# UNITED STATES PATENT AND TRADEMARK OFFICE

10/533,550

| <b>Office Action Summary</b> | <b>Application No.</b><br>10/533,550     | <b>Applicant(s)</b><br>GRAHAM ET AL. |  |

## **DETAILED ACTION**

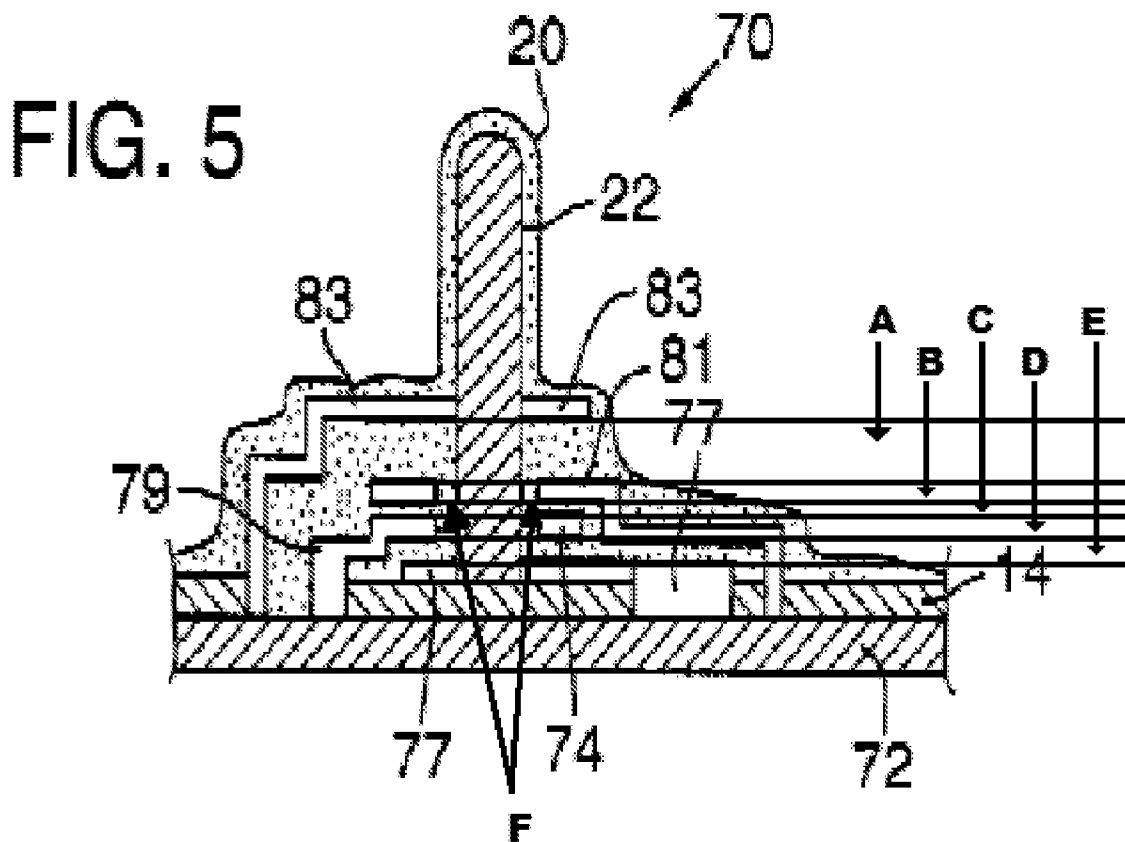
8. As for claims 22, 41, and 44, Farnworth discloses (Col. 7, lines 29 – 38) and show in Fig. 5 vertically integrated field-effect transistor comprising:

- a. a first electrically conductive layer (77);
- b. a middle layer (A, C, E), formed partially from dielectric material, on the first electrically conductive layer;

- c. a second electrically conductive layer (83) on the middle layer;
- d. and a nanostructure (22) integrated in a via hole introduced into the middle layer, the nanostructure further comprising a first end portion that is coupled to the first electrically conductive layer and a second end portion that is coupled to the second electrically conductive layer (Fig. 5),

- e. wherein the middle layer, between two adjacent dielectric sublayers, has a third electrically conductive layer (B), the thickness of which is less than the thickness of at least one of the dielectric sublayers (Fig. 5) (thickness of A is greater than B); and

- f. wherein a ring structure (F) (the ring is formed from the insulation layer around the nanostructure) formed from an electrically insulating material as gate-insulating region of the field-effect transistor is arranged in the third electrically conductive layer, along the via hole that has been introduced therein,

- g. wherein the middle layer has an additional electrically conductive layer (D), which at least one additional electrically conductive layer serves as an additional gate electrode of the field-effect transistor, with an additional ring structure formed from an electrically insulating material as an additional gate-

insulating region of the field-effect transistor being arranged along the via hole that has been introduced in the additional electrically conductive layer.

Figure 2

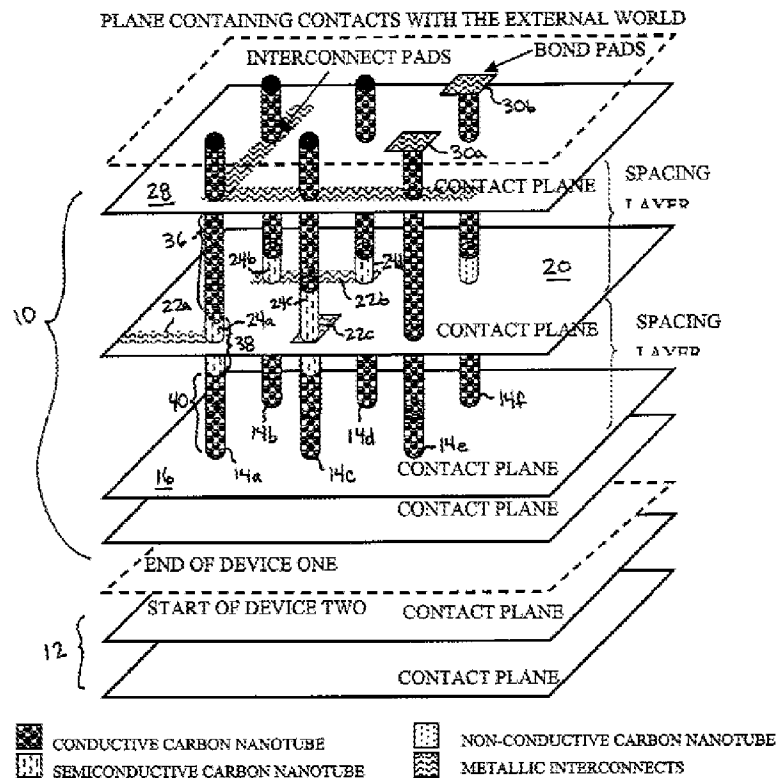
15. As for claims 22 and 41 – 43, Mancevski discloses (Page 3 [0040]) and shows in Fig. 2 a carbon nanotube transistor and method of manufacturing the same comprising:
- h. a first electrically conductive layer (16);
  - i. a middle layer /spacing layers(10), formed partially from dielectric material, on the first electrically conductive layer;
  - j. a second electrically conductive layer on the middle layer (28), and;
  - k. a nanostructure (14) integrated in a via hole/vertically aligned holes introduced into the middle layer, the nanostructure further comprising a first end portion that is coupled to the first electrically conductive layer and a second end

portion that is coupled to the second electrically conductive layer (as shown in the Fig, 2 both ends of the nanotubes are imbedded in the contact layer);

I. wherein the middle layer, between two adjacent dielectric sublayers/spacing layers, has a third electrically conductive layer (20), the thickness of which is less than the thickness of at least one of the dielectric sublayers (as shown in Fig 2, the contact plane is thinner than the spacing layers).

16. Mancevski fails to disclose use of a ring structure formed from an electrically insulating material as gate-insulating region of the field-effect transistor is arranged in the third electrically conductive layer, which forms the gate electrode of the field-effect transistor, along the via hole that has been introduced therein.

23. As for claims 24 – 25, Mancevski shows in Fig. 2 that the third conductive layer/contact layer (20) surrounds the nanostructure in the middle of the transistor as well as it been thinner than both dielectric layer/spacing layers.

25. As for claim 28, Mancevski shows in Fig. 2 that creation of a second transistor (12) next to the original transistor (10).

# FIG. 1

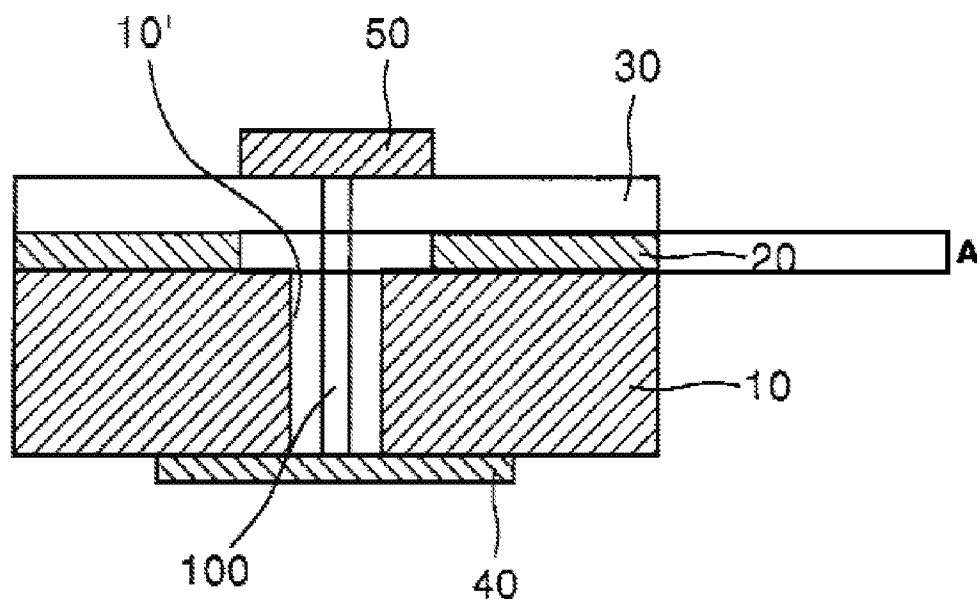
17. Choi discloses (Page 2, [0028]) and shows in Fig. 1 a FET transistor and method of manufacturing the same comprising a nanostructure (100) and the use of an insulation ring (A) in the are of the gate (20) of the transistor.

18. Choi is evidence that ordinary workers in the art would find a reason, suggestion or motivation to use a ring structure in the gate area made of an insulating material.

19. Therefore, it would have been obvious to one of ordinary skill in the art at the time of the invention was made to modify Mancevski by using a ring structure in the gate area made of an insulating material for advantages such as achieving a high-density integration in the final structure of the FET (Page 2, [0028]).

*Fig. 1*

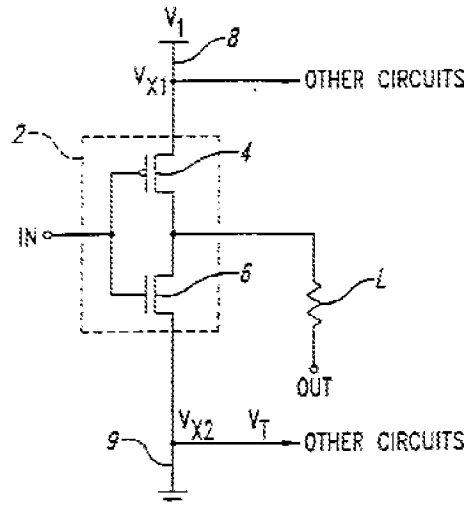
**32. Claim 29 rejected under 35 U.S.C. 103(a) as being unpatentable over Mancevski in view of Martin et al. US 2001/0019279 (Martin).**

33. As for claim 29, Mancevski discloses the claimed invention except for the use of the transistors as an inverter circuit. It would have been obvious to one of ordinary skill in the art at the time of the invention was made to connect both transistors as a inverter circuit since it was known in the art that, as evidence in Martin, that the inviter circuit (2) takes the use of two transistors (4,6) connected as in Fig. 1 above. Furthermore, It would have been an obvious matter of intended use to connect both transistors as an inverter circuit, since applicant has not disclosed that this connection solves any stated problem or is for any particular purpose and it appears that the invention would perform equally well in any other circuit with the need of two transistors. Finally, a recitation of "as an inverter circuit" of the claimed invention does not result in a structural difference between the claimed invention and the prior art, thus claimed invention is only an art-recognized suitability for an intended purpose, MPEP 2144.07.
